January 12, 2018

Re: South Mall Campus Master Plan Draft Environmental Impact Statement (EIS)

Figure 1. Twenty percent of the south mall campus is covered by tree canopy today.

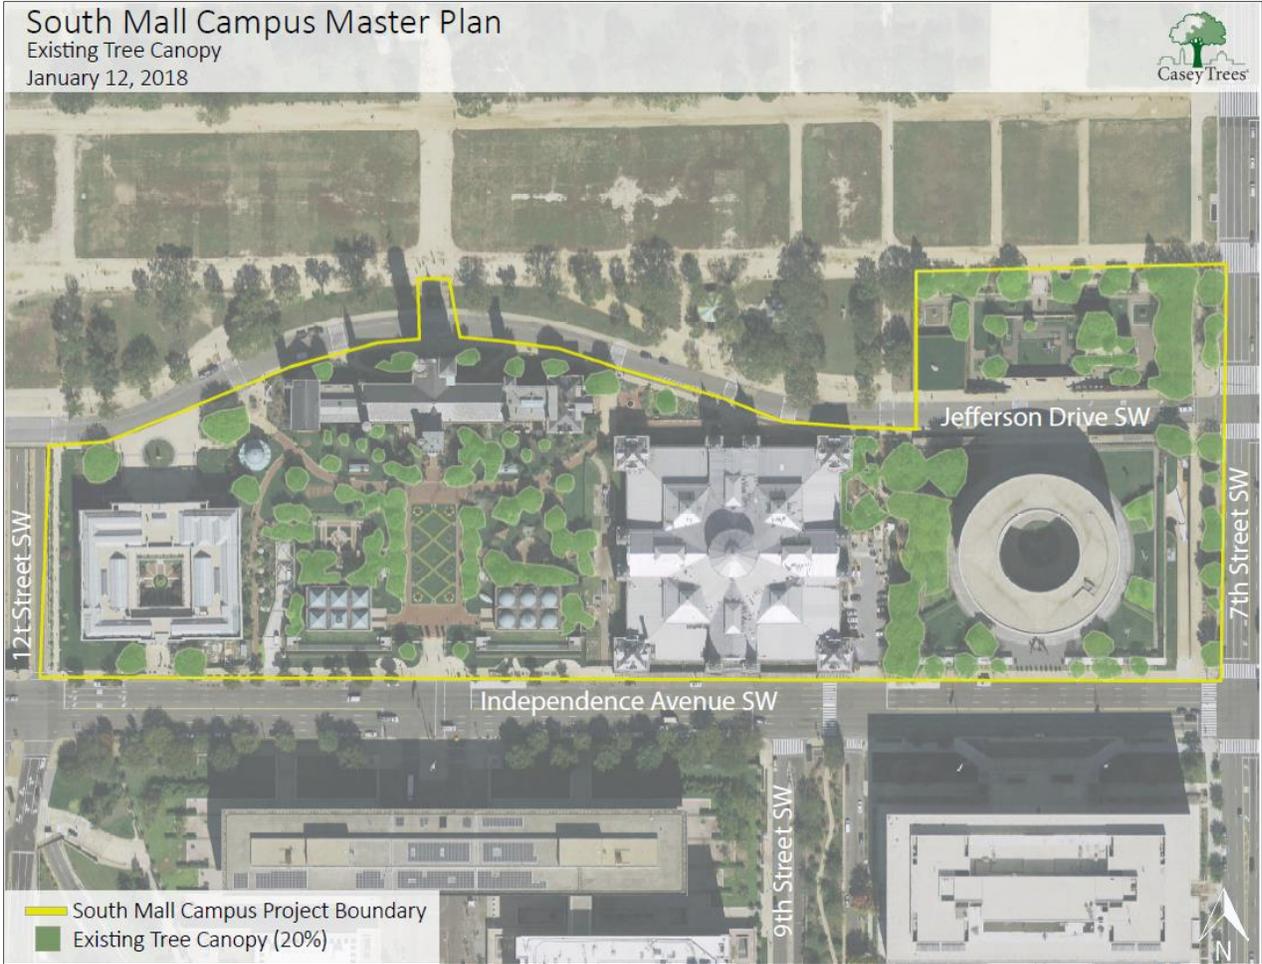
Our analysis shows that 20% of the south mall campus is covered by tree canopy today (Figure 1). The EIS is an opportunity to highlight the importance of tree habitat by committing to covering no less than 20% of the south mall with tree canopy post-construction. Today, 35% of the south mall campus is plantable space (Figure 2). A 20% tree canopy will be easily attainable by adopting Alternative B, which strives to maintain the same area of plantable space long term.
